Air Quality Permitting Response to Public Comments

**Permit to Construct No. P-2015.0056
Project 61607**

**Alta Mesa Services, LP
Kauffman 1-34
New Plymouth, Idaho**

Figure 1: Concentration Contours for 1-Hour NO₂ Design Value Impacts
Background Concentrations not Included

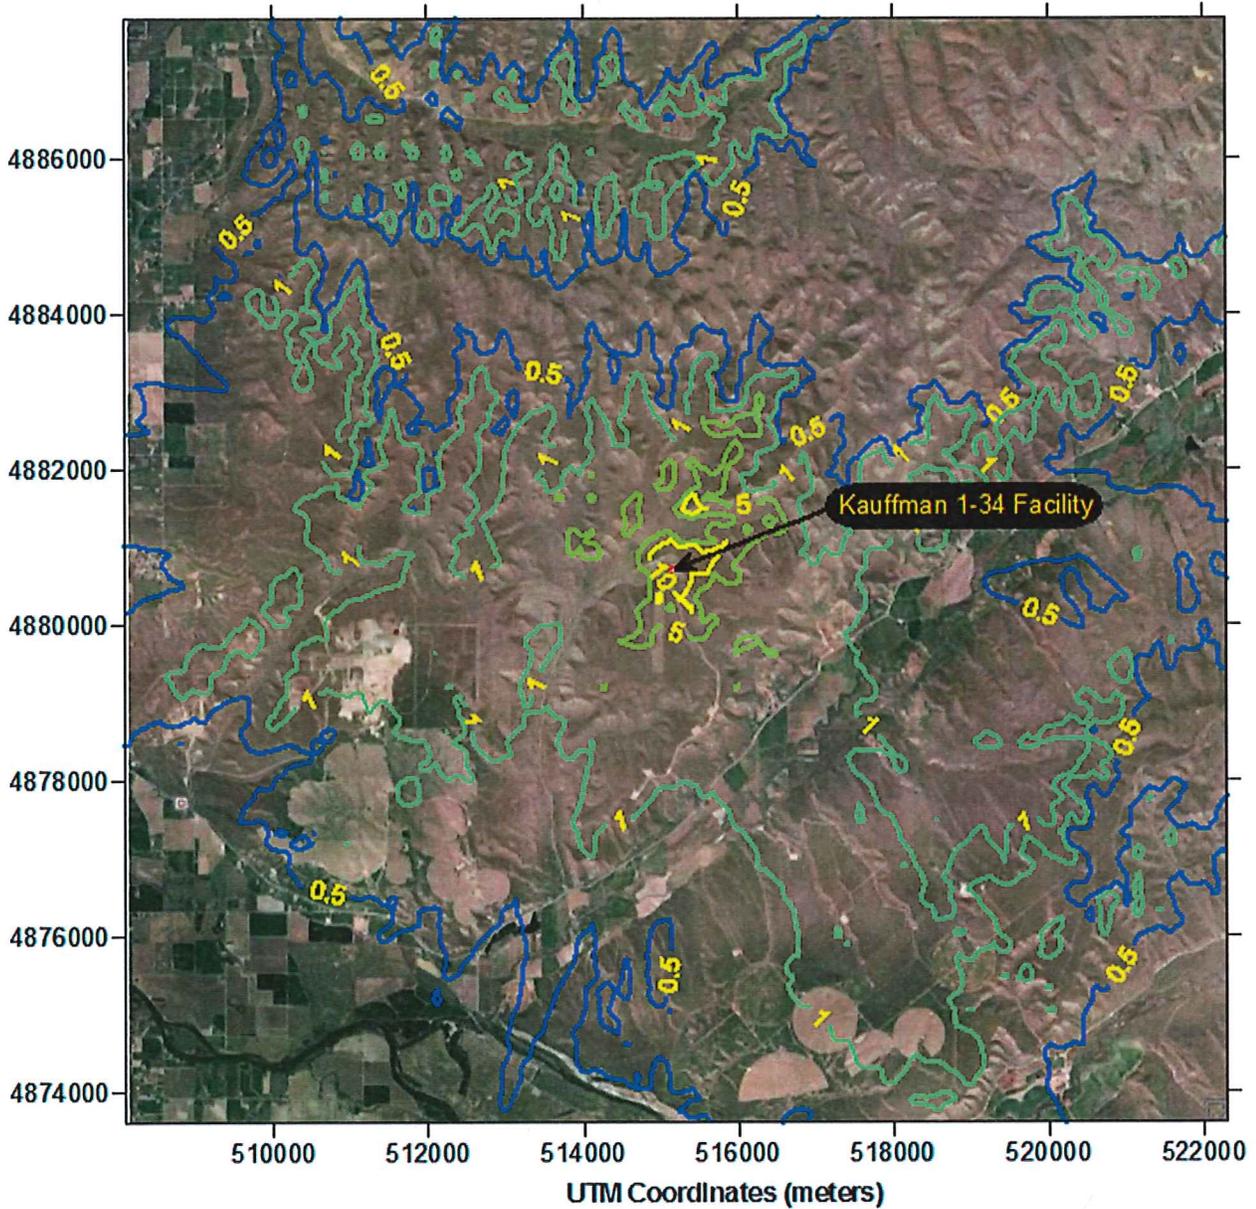
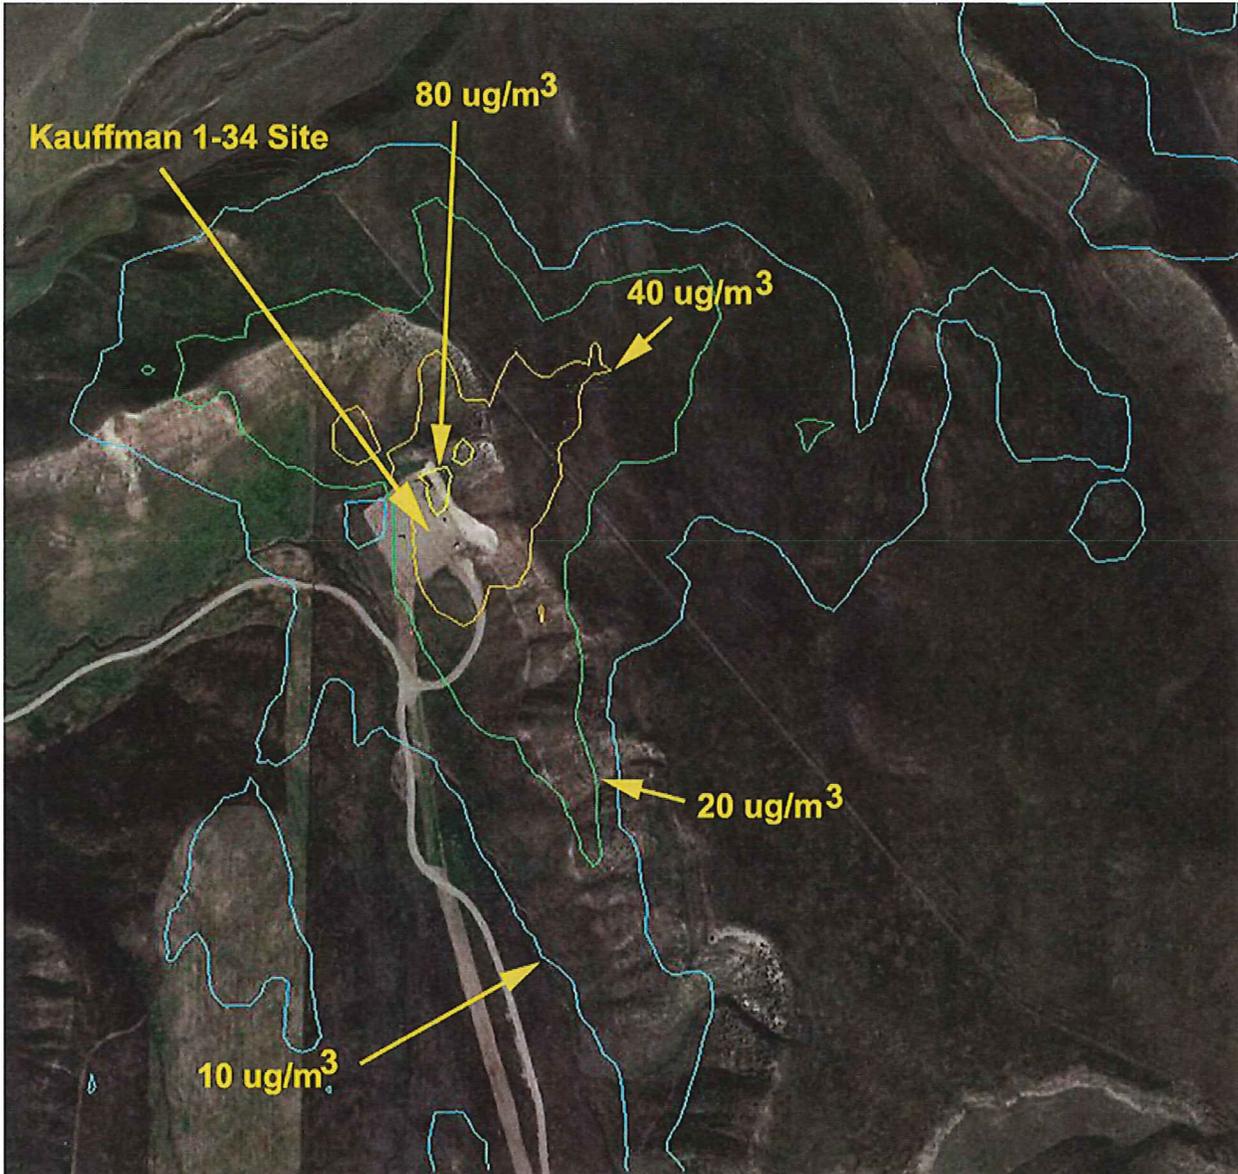
Comment 1: We strongly encourage DEQ to aggregate emissions from this well with all of the current or future wells within this valley. DEQ’s air impact modeling results highlight that emissions from these well sites have broad dispersions, impacting air quality up to 7 miles away from the source (Attachment 2: Figure 1 from DEQ’s Modeling Memorandum). The emissions from these wells will undoubtedly combine in the atmosphere and have a cumulative impact greater than what is predicted by solely analyzing each well site as an individual entity. Treating each well site does not capture the whole picture, and may inadvertently fail to predict harmful air quality violations as a result of cumulative impacts.

DEQ also disagrees with the comment stating that emissions from this site should be aggregated with all current or future wells within this valley when evaluating the air impacts. Within

approximately 0.4 miles, design value (equal to the 5-year average of upper 98th percentile impacts of the annual distribution of maximum daily 1-hour impacts, consistent with the form of the 1-hour NO₂ standard) drops to levels below 10 µg/m³. Within about 3 miles, design value impacts drop to levels below 1.0 µg/m³ at most locations.

DEQ analysts, responsible for evaluating air impact analyses of potential emissions from facilities applying for air emissions permits, conclude that it is unlikely a similar neighboring facility located outside of ¼ mile could have a measurable effect on the maximum design value impact for the 1-hour NO₂ standard. This is based on the magnitude of NO_x emissions from the well site facilities. The plume of the two sources must overlap almost exactly during a period when the primary source has relatively high impacts to enable a measurable co-contributing impact for a 1-hour averaging period. The probability of this is small for sources separated by more than ¼ mile. Also, the conservative manner in which background concentrations are considered in the analyses, using the design value concentrations for both the modeled impact and the background concentration, provides an adequate level of NAAQS compliance assurance.

Figure 1: Concentration Contours for 1-Hour NO₂ Design Value Impacts
Background Concentrations not Included

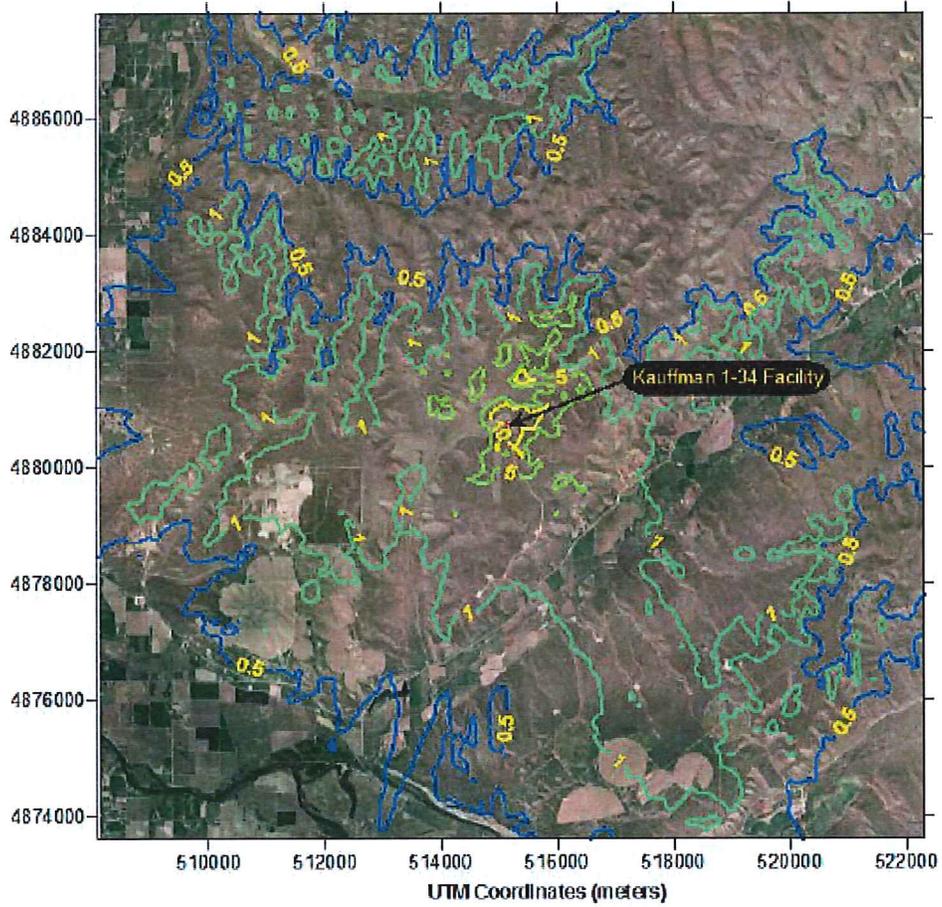
Results from NAAQS impact modeling for this well indicate that emissions from this source will span roughly 7 miles (Attachment 2). The majority, if not all of these wells will reside within the 1 $\mu\text{g}/\text{m}^3$ increase in 1-hour NO_2 contour. As a result portions of the valley within the immediate vicinity of all of these wells will experience at a minimum an increase in 1-hour NO_2 concentrations of 6 $\mu\text{g}/\text{m}^3$, bringing background concentrations for 1-hour NO_2 up to at least 58.6 $\mu\text{g}/\text{m}^3$. This increase could have serious implications if wells have total maximum concentrations modeled close to the NAAQS threshold.
